## **Microboone Tank Insulating support**

### **Abstract**

It has been proposed to support the MicroBooNE tank with load bearing foam insulation. We identify some concerns and propose two coherent concepts in response.

**Thermal Contraction of Insulations vs. Steel (70°F to -300°F)**

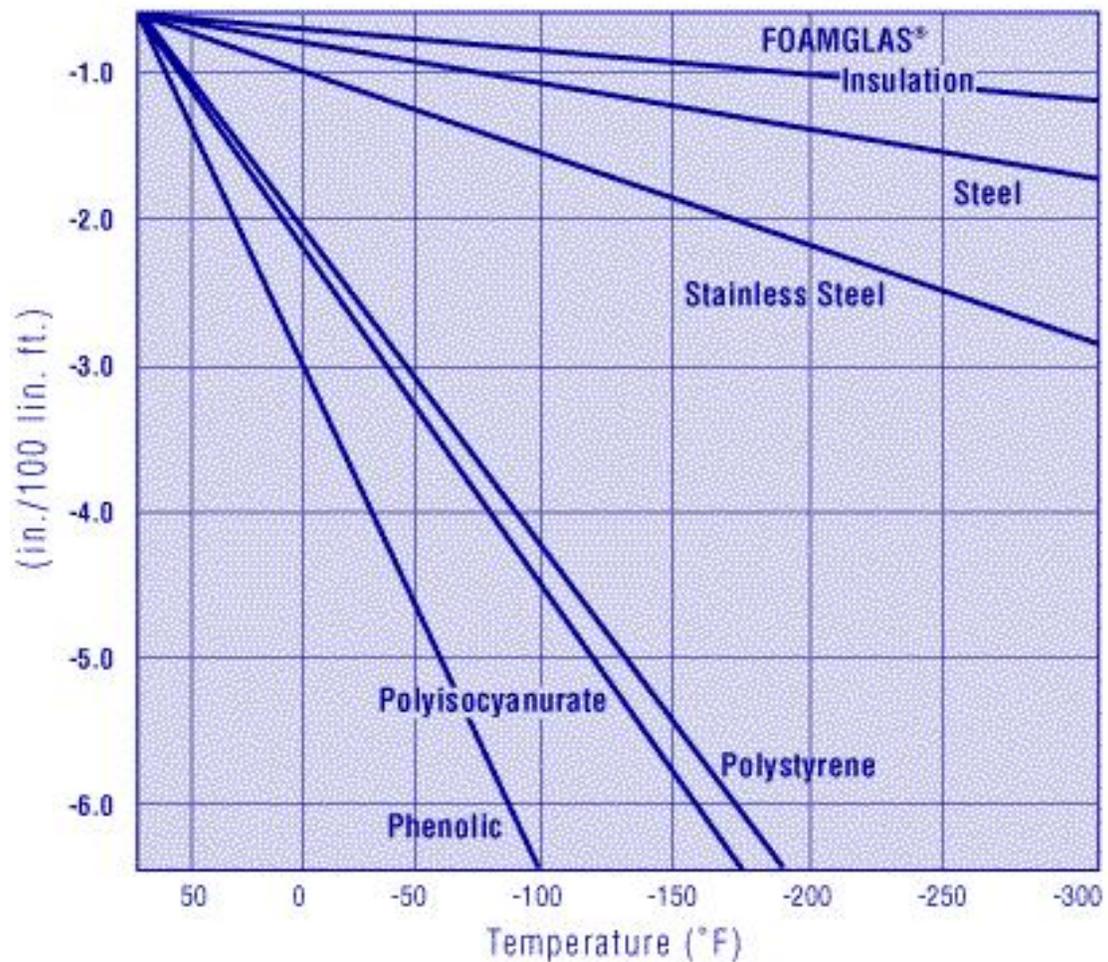
PU shrinks by 1.0 % during cooldown to Lar temperature (about 87 K) [see below and Ref. 4].

Stainless steel (SS) tank material shrinks less 0.3 %.

(Foamglas shrinks 0.07 %)

**Figure 1**

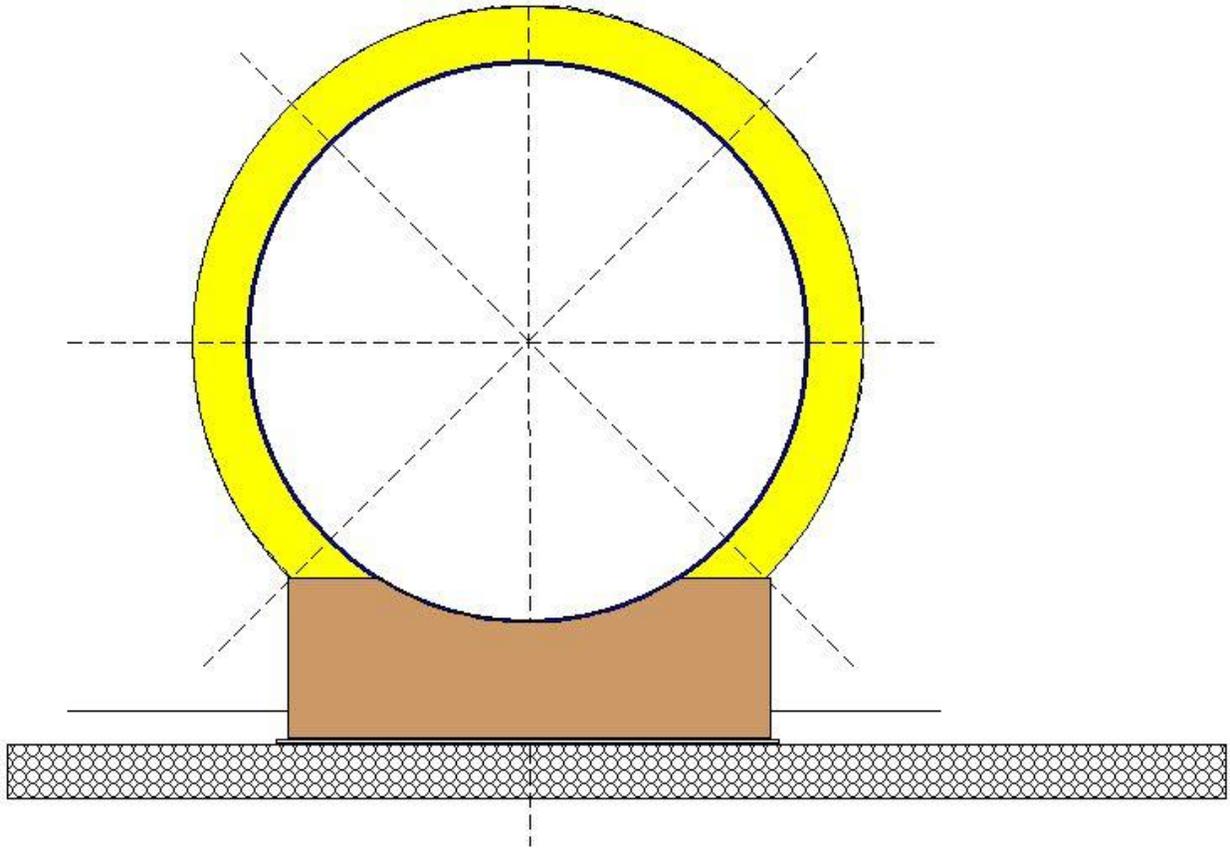
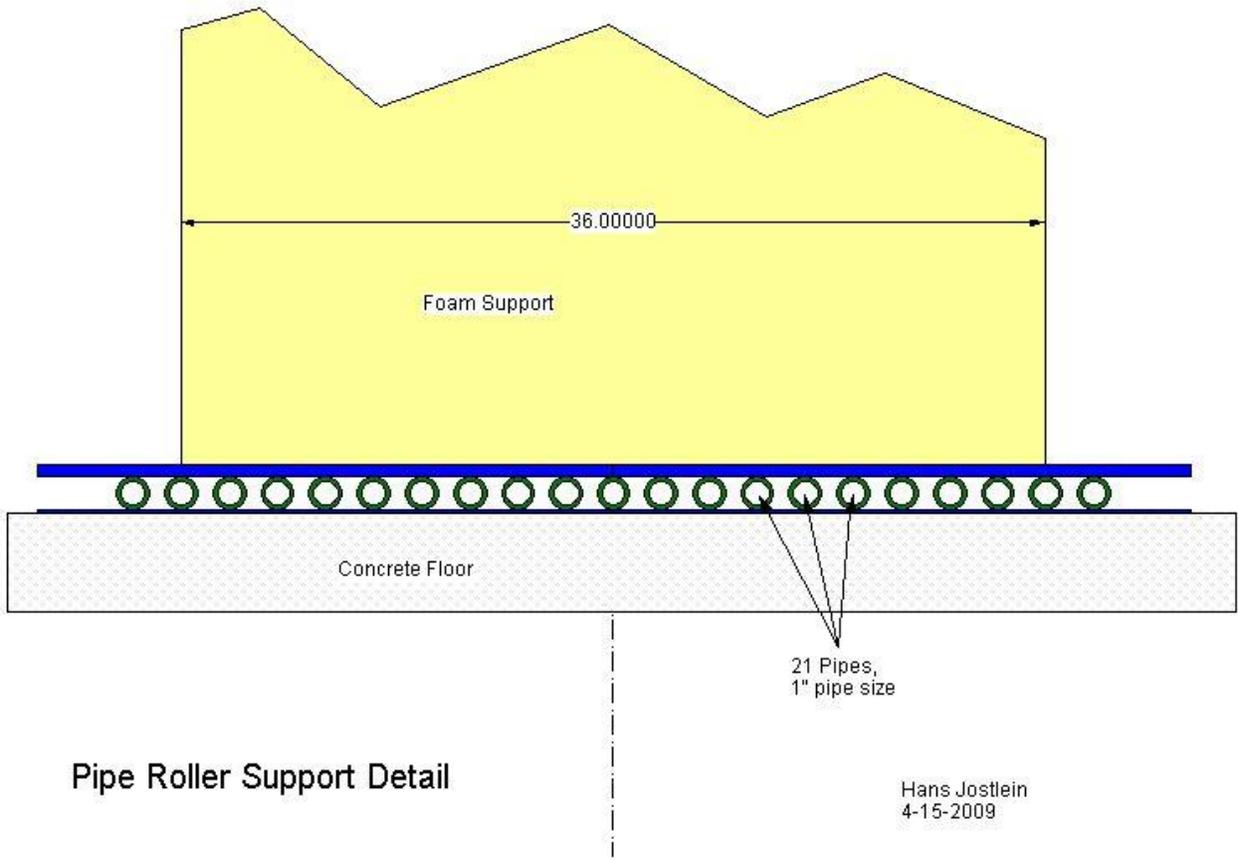
The concept, as shown in Figs. 1 and 2, has two foam supports, each about 1 m wide. One of them sits on an aluminum sheet, supported by pipe rollers. The other foam support sits on an equal-height shim plate. The supports are grouted to the plates for even loading. The tops of the supports, which are cradle-shaped, are also covered with grout where they contact the PE foil-covered tank.

On cool-down the fixed support stays in place, while the support on the roller-pipes moves to accommodate the shortening of the tank, a little over 1 cm between the supports.

Figure 3

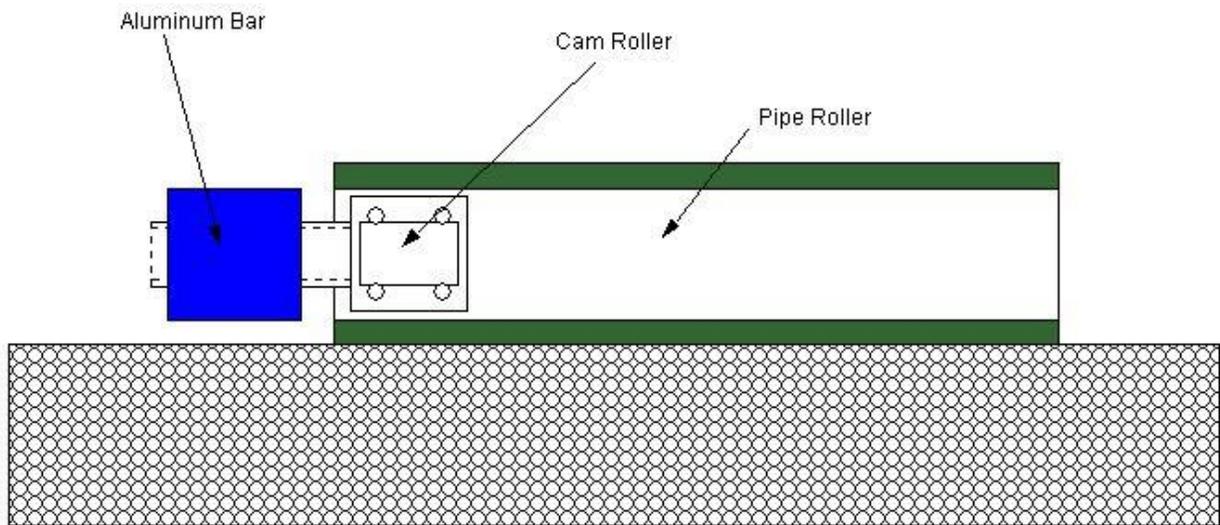
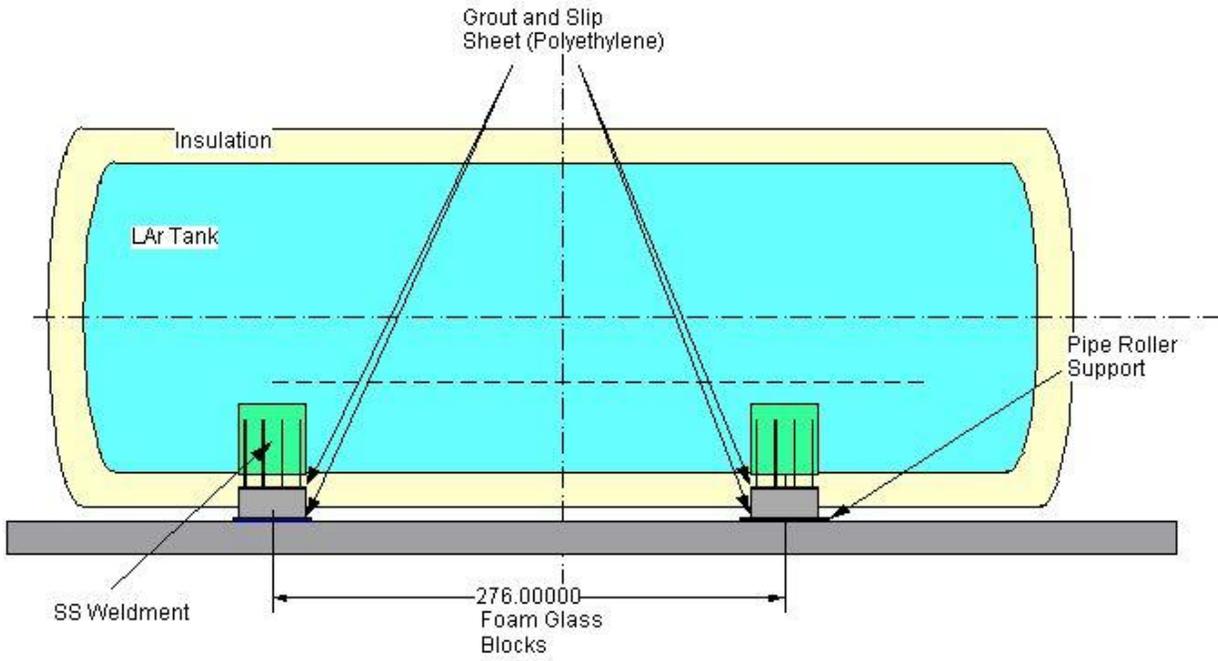
Lastly, even at the reduced friction coefficient of 0.25, the foam support suffers an avoidable shear stress at cool-down. The stress can be sharply reduced by building one of the foam supports on top of an array of roller-pipes, as shown in Figs. 3 and 4. The pipes are kept parallel and evenly spaced by pairs of cam rollers, screwed into a longitudinal bar at each end of the pipe field. The expected friction factor will be about 0.05, essentially removing the shear stress in the support.
